VEPCO NOMAD CODE AND MODEL SUPPLEMENTAL INFORMATION.

Docket # 50-280
Control # 8407170305
Date 7/6/84 of Document:
REGULATORY DOCKET FILE

RESPONSE TO QUESTIONS AND COMMENTS ON VEPCO NOMAD CODE AND MODEL (VEP-NFE-1)

FIGURE 4.1

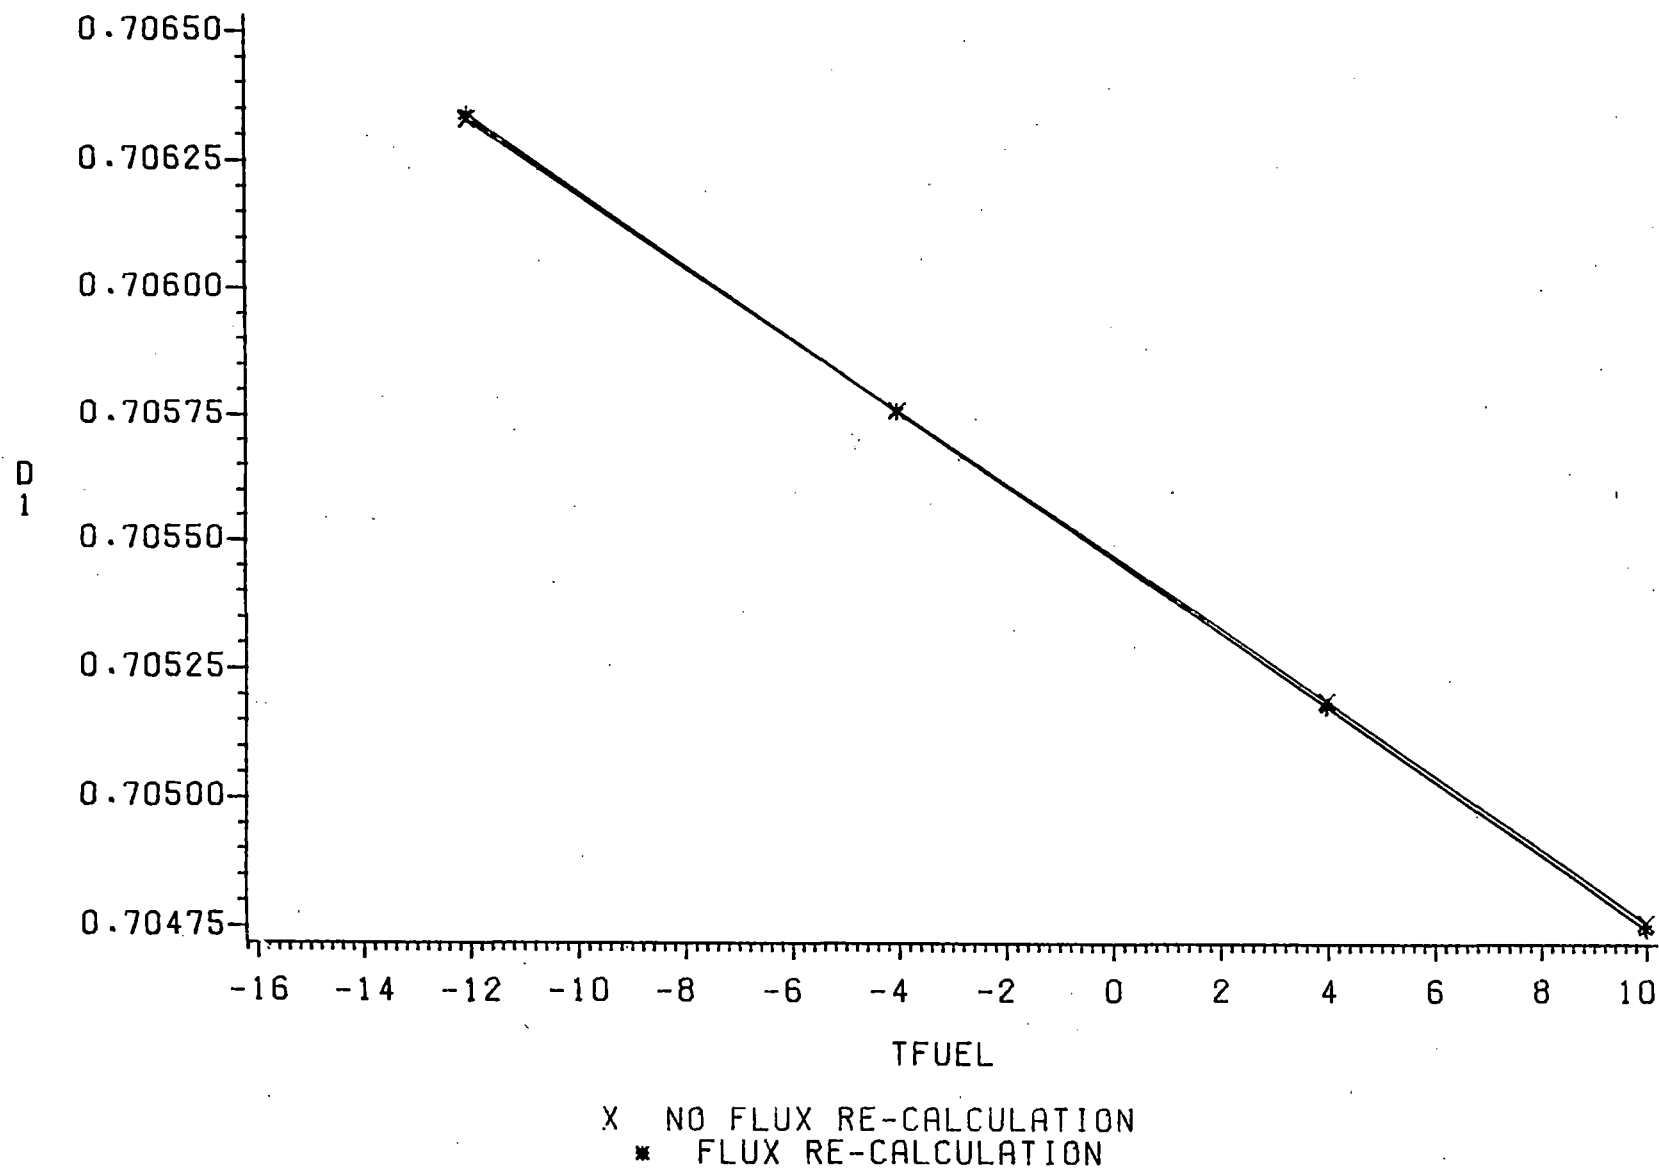
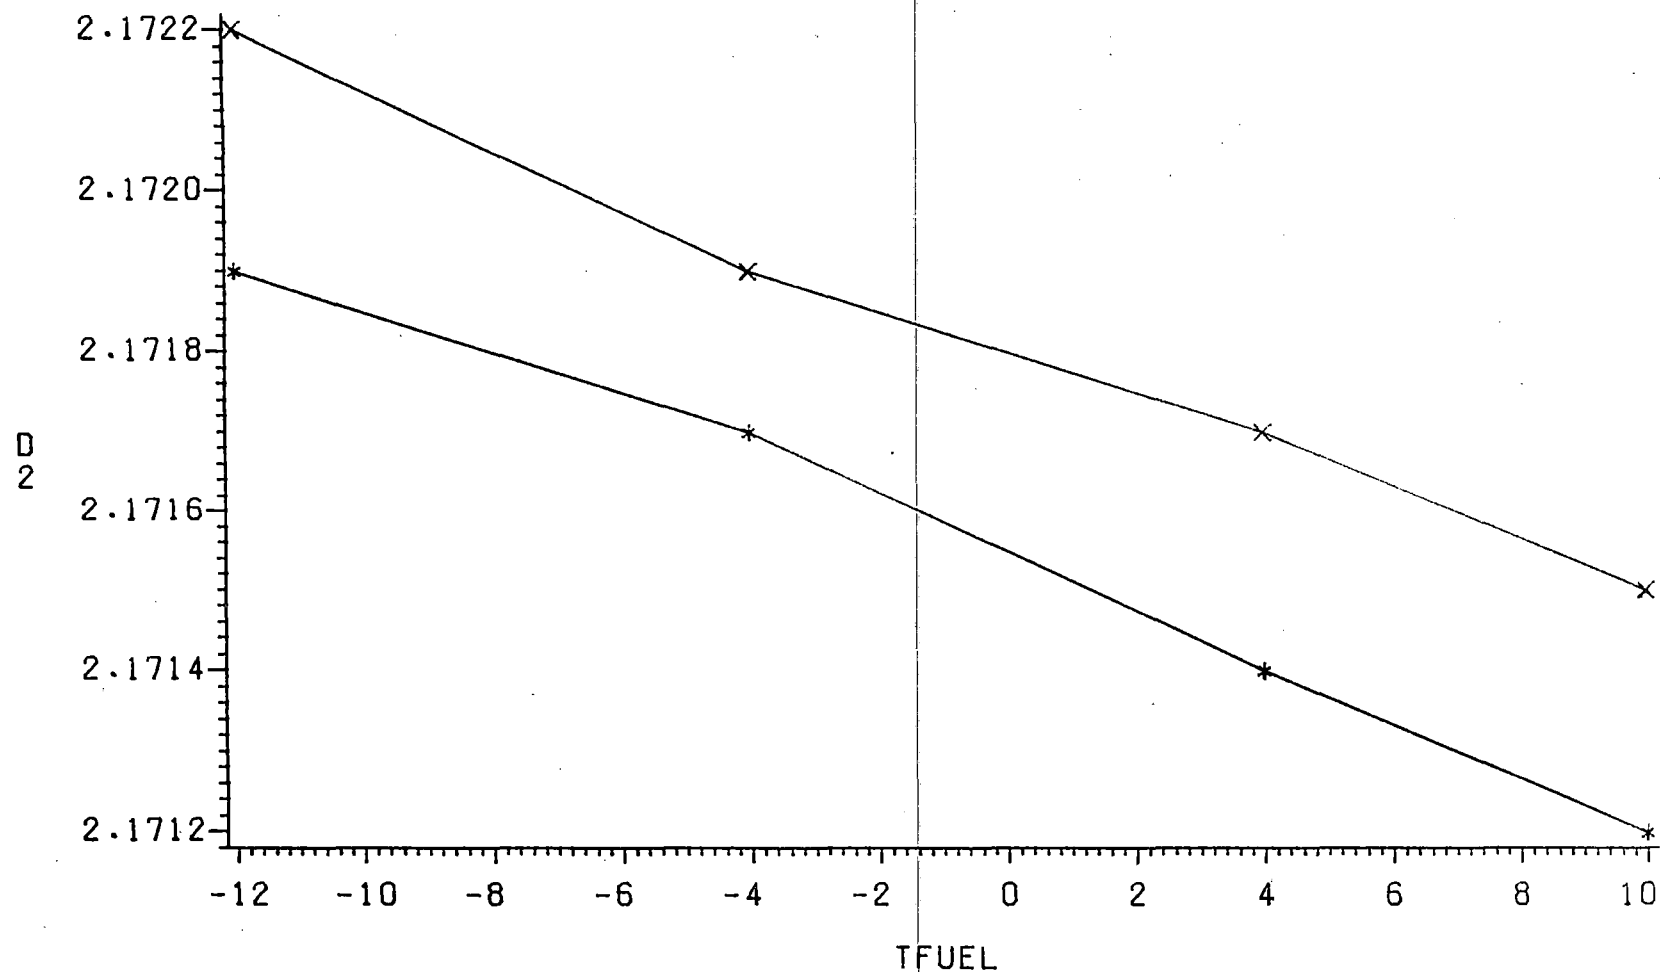
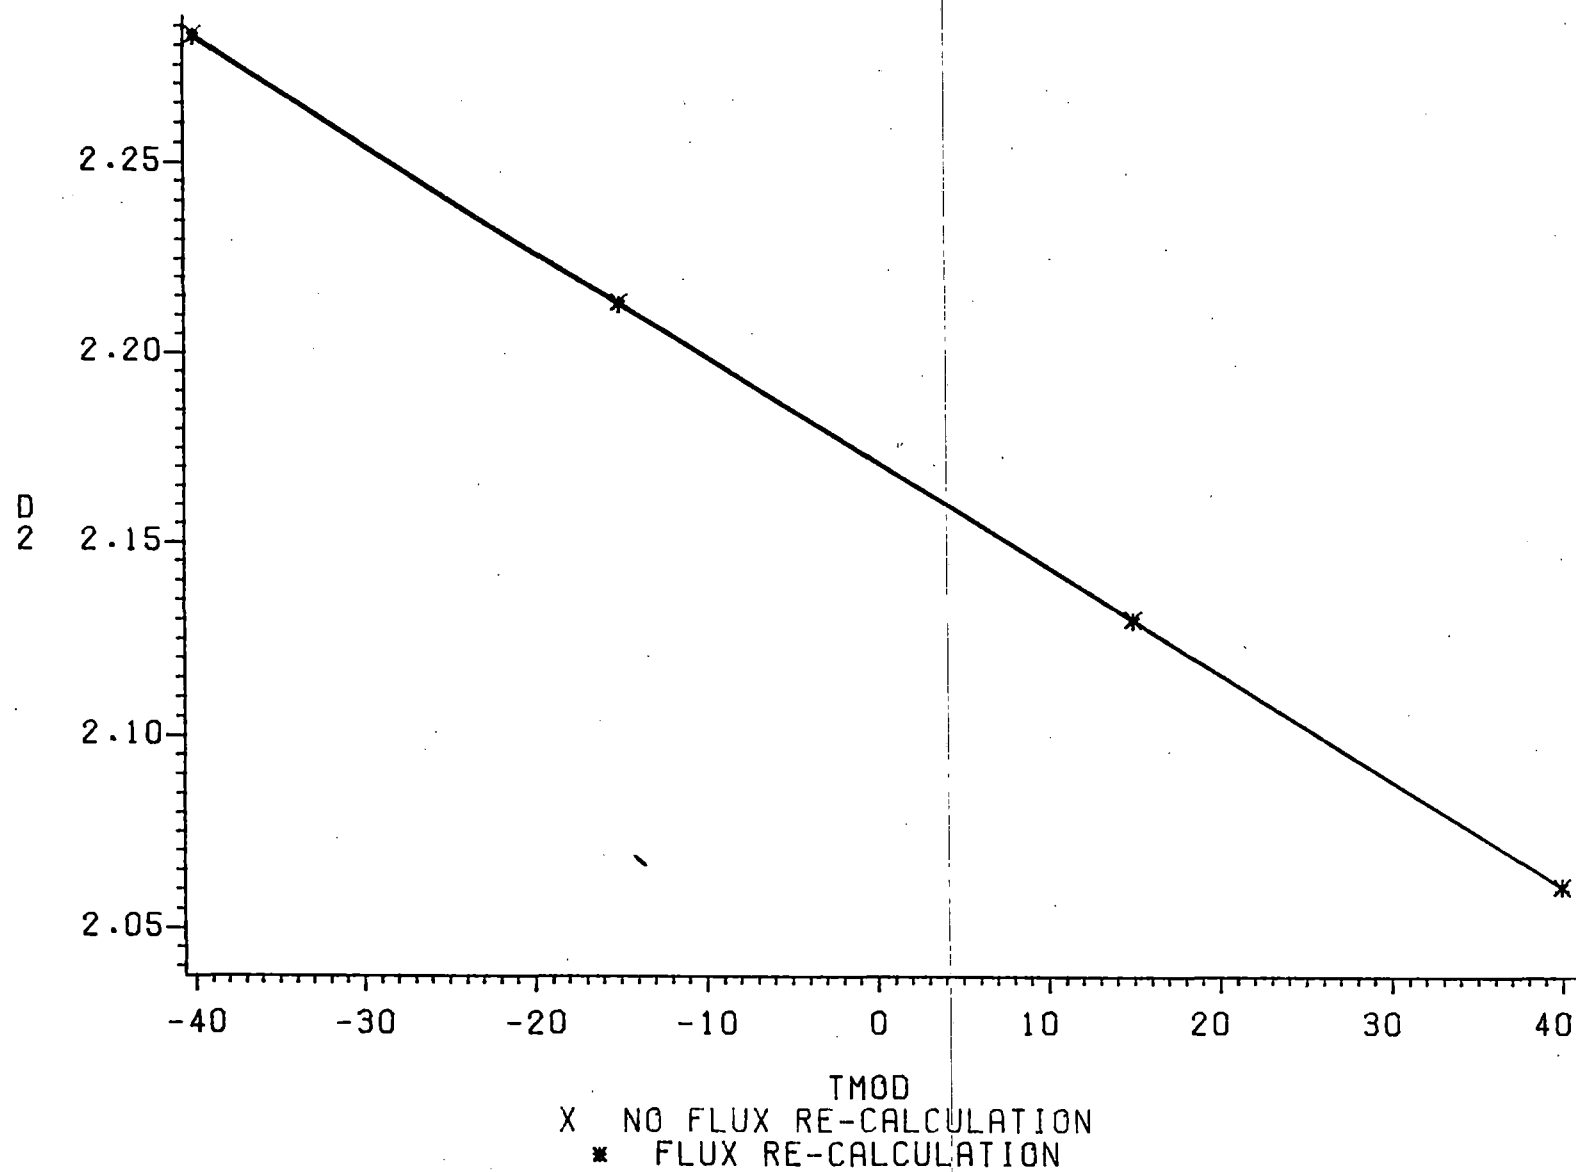
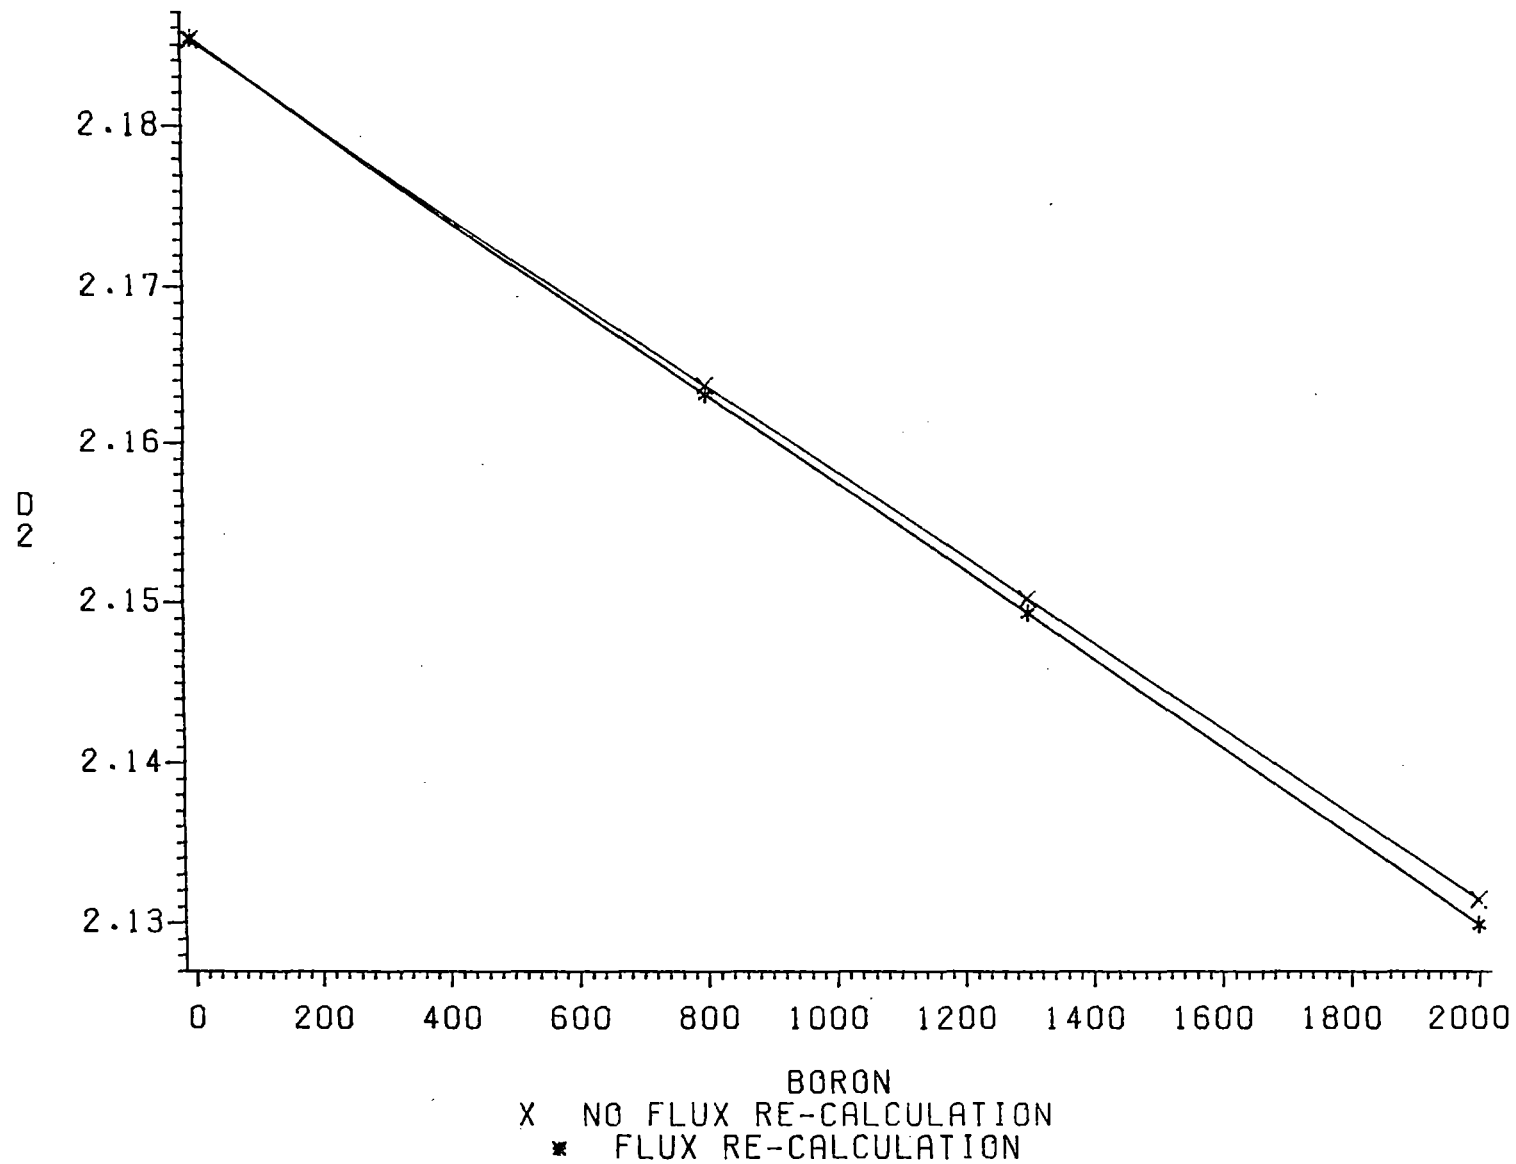
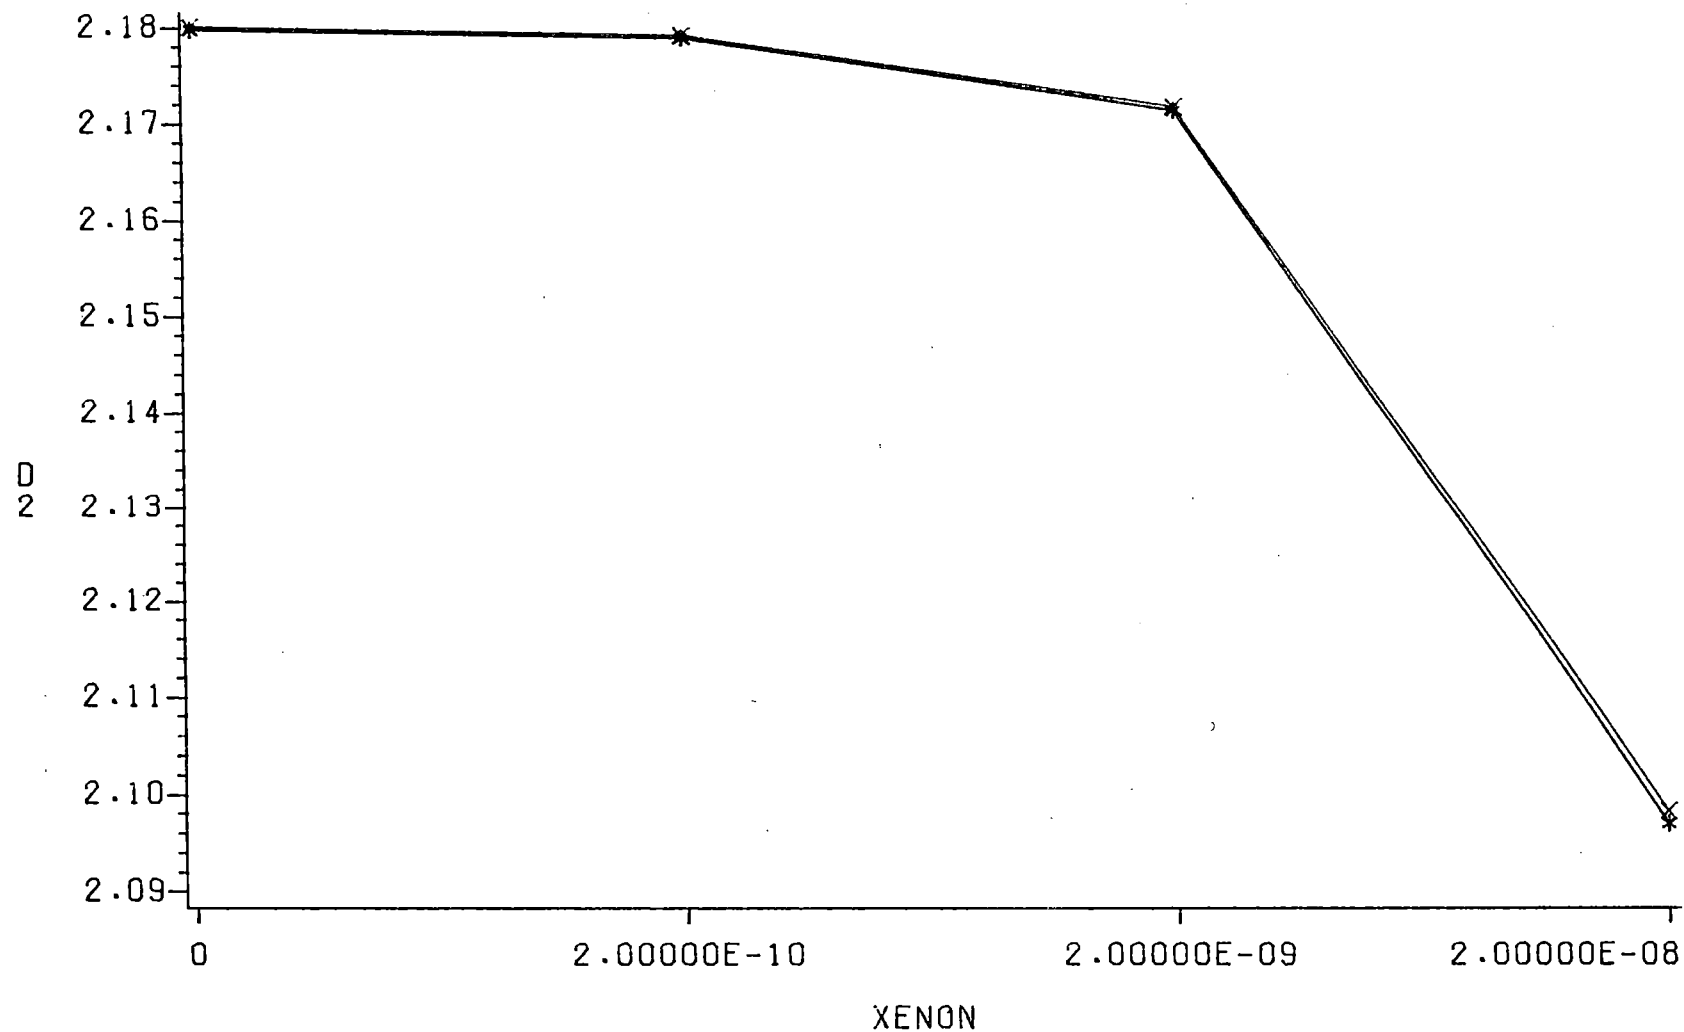
Question 4. The use of re-edits which do not involve flux calculations for off-nominal conditions is a feature of other procedures (e.g., ARMP). However, those procedures are usually concerned with long term burnup analyses. The adequacy of this type of treatment for some of the NOMAD applications should be justified.

A series of restart flux and eigenvalue calculations were performed with the PDQ07 One Zone model at one burnup step. The macroscopic cross sections obtained from these calculations were input to the XSFIT and XSEXP codes to calculate the cross section coefficients in accordance with the procedure described in Response to Question No. 3 above. The macroscopic cross sections predicted with these coefficients are compared to similar results using the normal methodology without flux re-calculations for off-nominal conditions in Figures 4.1 through 4.31. The results are virtually identical for most cases, and the maximum difference for all cases is 0.1%.
